Office Action Summary

10/675,736

SHEN ET AL.

FIG. 24A

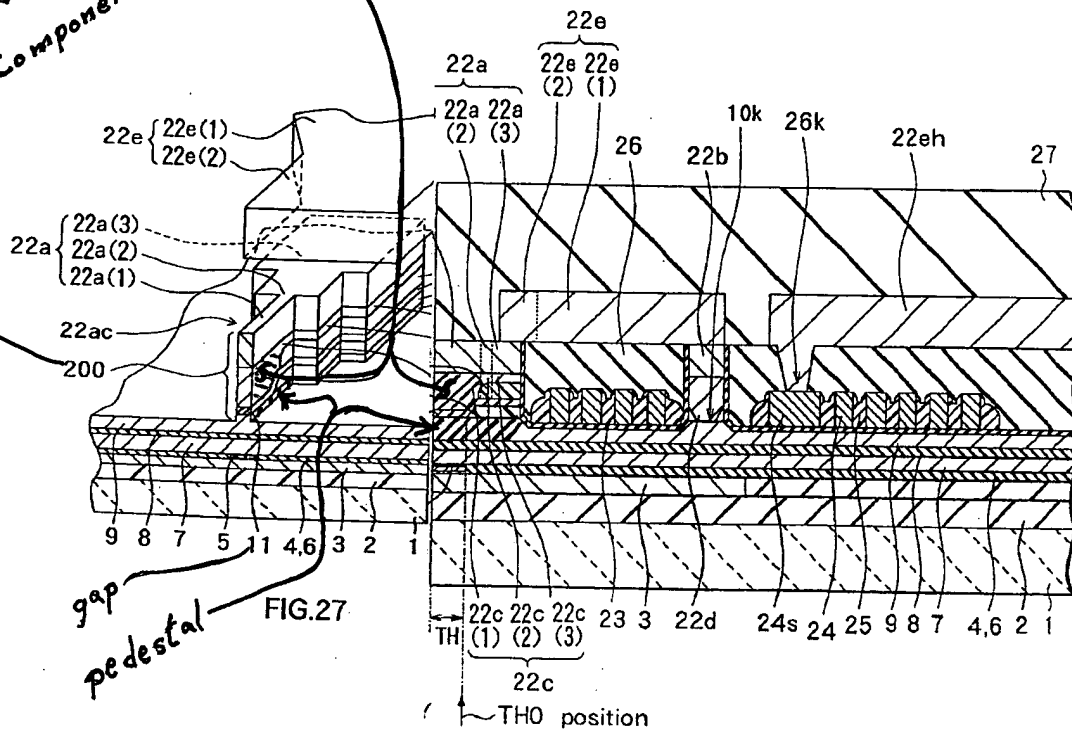
See Figs. 24A&B and 27. To the extent claimed and understood, the structure as shown in Addendum A reads on and performs to the same degree as claimed.

Note that the first component has a ZTH(noted in figure 24A and Addendum A as 'TH') which is less the height of the pedestal (blue section lines in Addendum A).
